UNITED STATES PATENT AND TRADEMARK OFFICE

Office Action Summary	Application No. 10/593,784	Applicant(s) SUZUKI ET AL.	
	Examiner Jeffrey R. West	Art Unit 2857

DETAILED ACTION

FIG.6

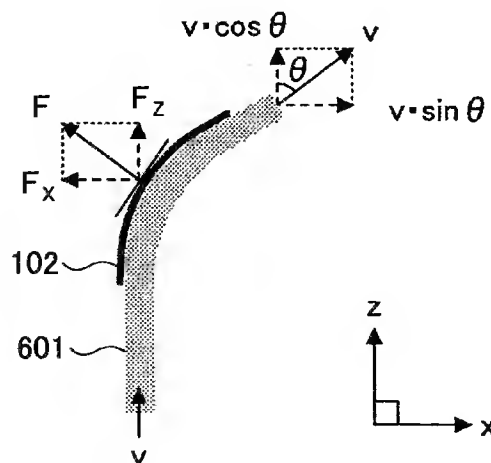
The Examiner asserts that, as can be seen by the citation and Figure provided above, a first horizontal/perpendicular force F_x is created due to a vertical force

impacting a curved inclined side of a receiver. This force is inherently generated anytime a vertical force impacts such a curved inclined side of a receiver.

Figure. 1 Concept.

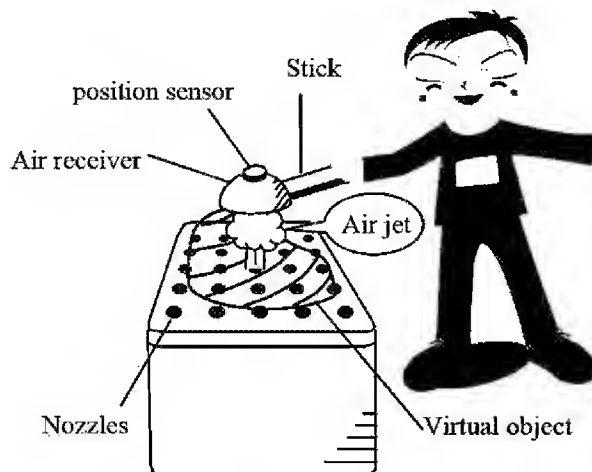
Turning to Suzuki, Suzuki discloses a receiver with such curved inclined sides that is impacted by such vertical forces:

Therefore, the Examiner asserts that one having ordinary skill in the art would recognize that the receiver of Suzuki does convey a force in a “direction perpendicular to a direction of the jetting gas or liquid”.

Additionally, since the receiver of Suzuki has two opposing curved inclined sides that are both impacted by vertical forces, and since the cited portion of the instant specification discloses that such impact of a force on an opposing side of a curved inclined side creates an opposing horizontal/perpendicular force, one having ordinary skill in the art would recognize that the receiver of Suzuki does provide a

force in first and second directions of force with "the first direction and the second direction being perpendicular to the direction of the jetting gas or liquid".
